Arlington Zoning Board of Appeals

Date: Tuesday, August 15, 2023
Time: 7:30 PM
Location: Conducted by remote participation
Additional Details:

2. #3747 10 Sunnyside Avenue

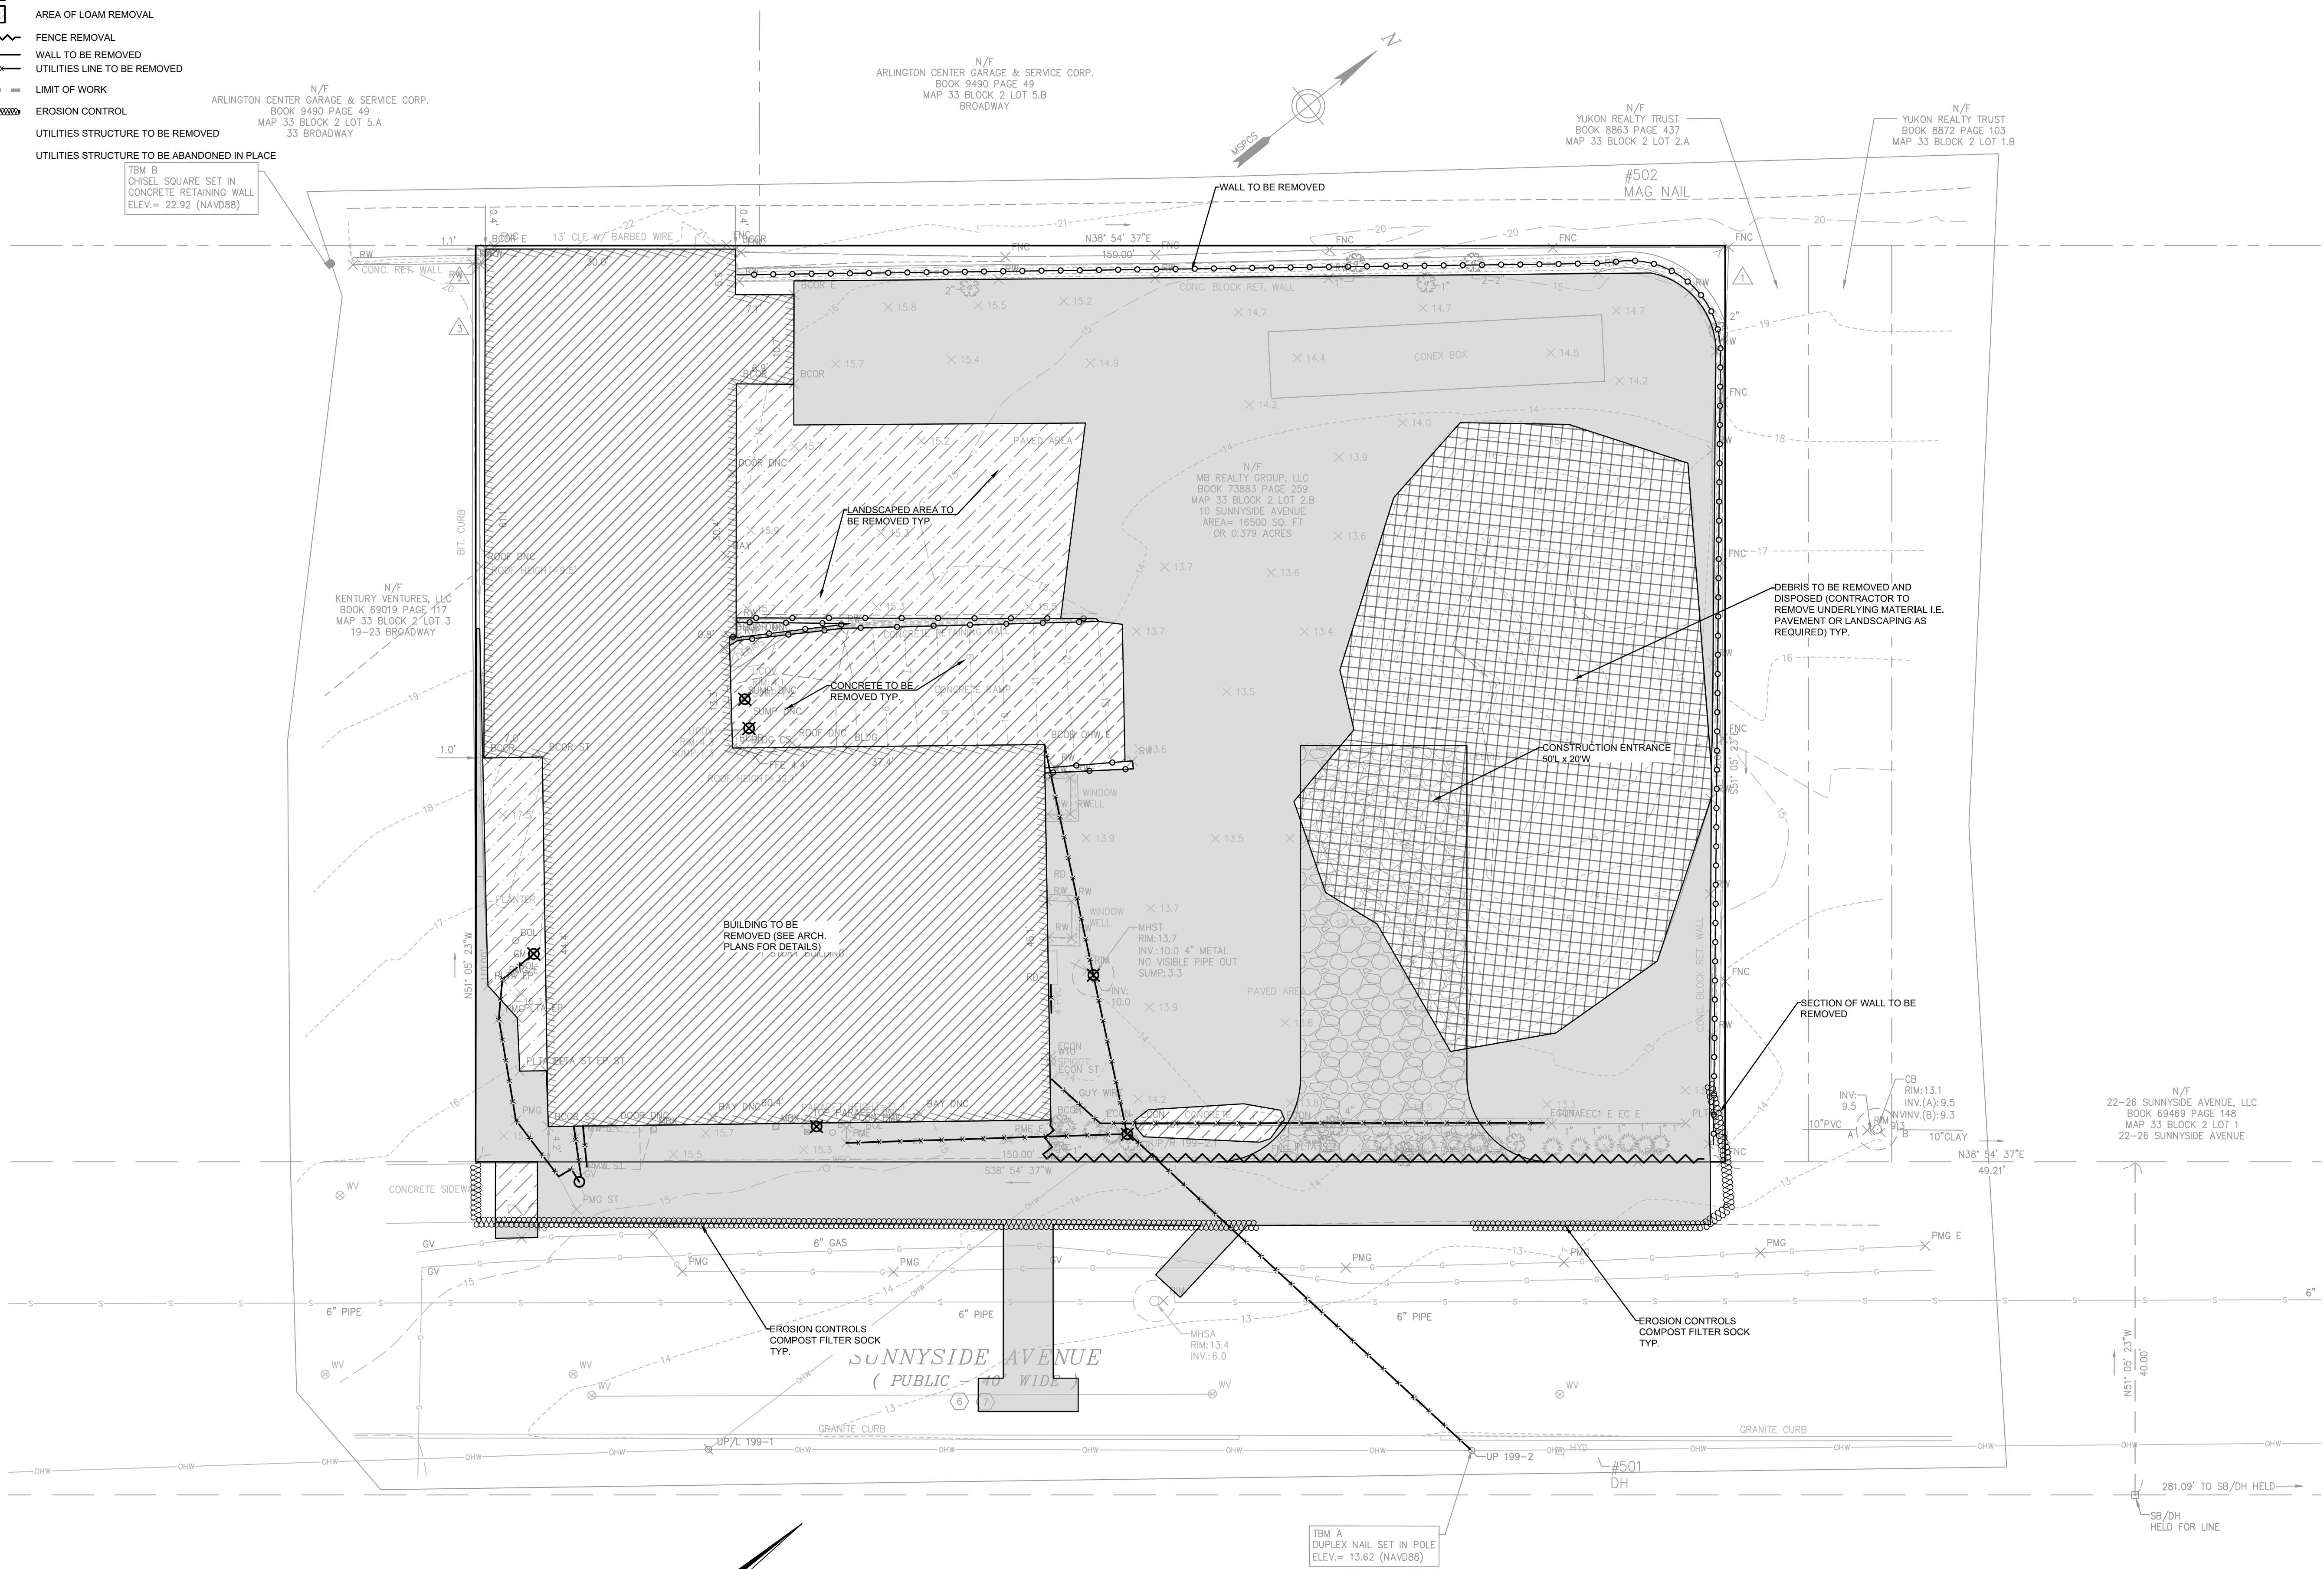
***Response:** Refer to EV plan submitted to the board on 6/9/2023.*
- How will the transformer be screened?
***Response:** The design team will develop a landscaped approach to screening the transformer.*

- Will PV panels be flat or raised ?

Response: PV panels will be ballasted roof-mount system approximately 18" tall; they will not be visible from the street.
